**PRELIMINARY GEOTECHNICAL INVESTIGATION  
GRANDVIEW RESERVE, FILING 1  
EASTONVILLE ROAD AND U.S. HIGHWAY 24  
FALCON, COLORADO**

Project No. CS19345-115-R2

January 6, 2022  
Revised March 14, 2022  
Revised May 9, 2022

SF-23-11

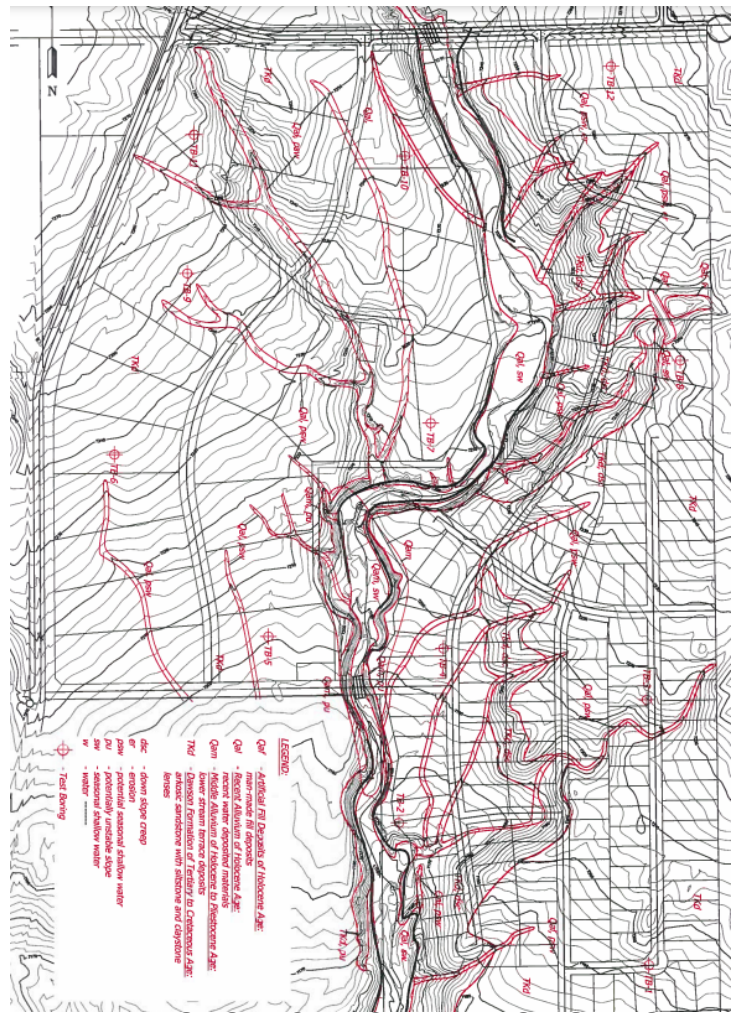
↑ a figure is missing depicting the various constraint and hazard mapping over the lot layout which was deferred from the preimplan- see sample
